RFP Title: Trinity Square Area Water Main Rehabilitation

Addendum #: 4

Issue Date: 08/10/2023

CONTRACT NO. 8-23

Attachment 1 Partial Drawing Revision - Sheet C-9

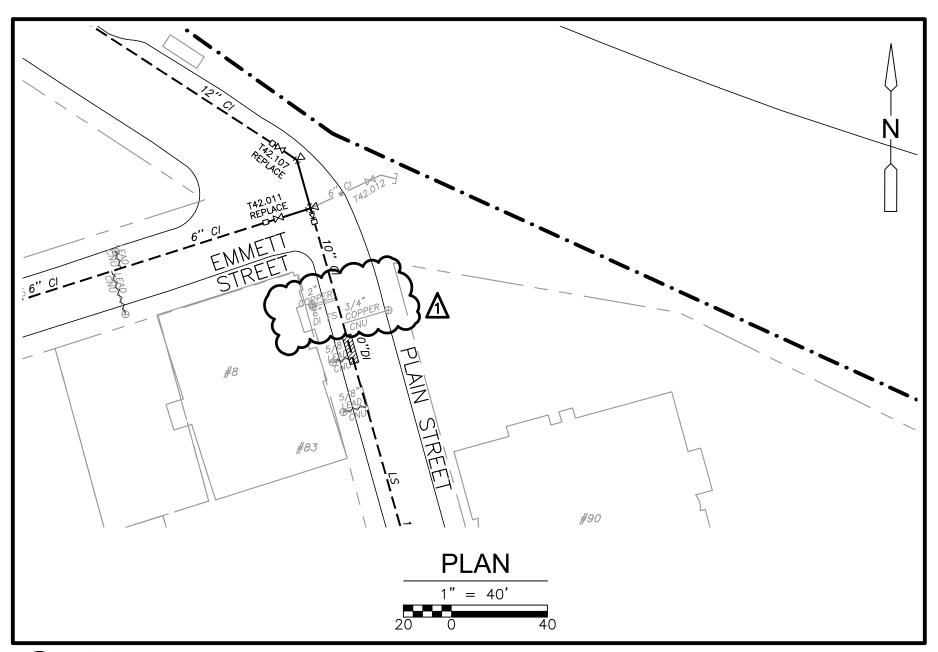
1. MODIFY Sheet C-9 with Attachment 1.

- 4. QUESTION: Providence Water requires 304SS hardware on the coupling devices in spec section 02616, 2.06,D. or has this standard been changed for this project? RESPONSE: 304 stainless steel bolts and nuts shall be furnished with all buried items. The specification section was updated in Addendum No. 4.
- 5. QUESTION: Good Morning, you sent an addendum out stating that that all fire services must be fed with the same diameter bypass. In the past 6" bypass was used for all large fire services. Does this mean that for a 10" fire service, we will have to run 10" bypass? RESPONSE: The 10" Fire Service identified on Sheet C-9 is shown incorrectly and should be a 6" fire service as shown in Attachment 1 Partial Drawing Revision Sheet C-9. Thus, a 6" bypass is required.
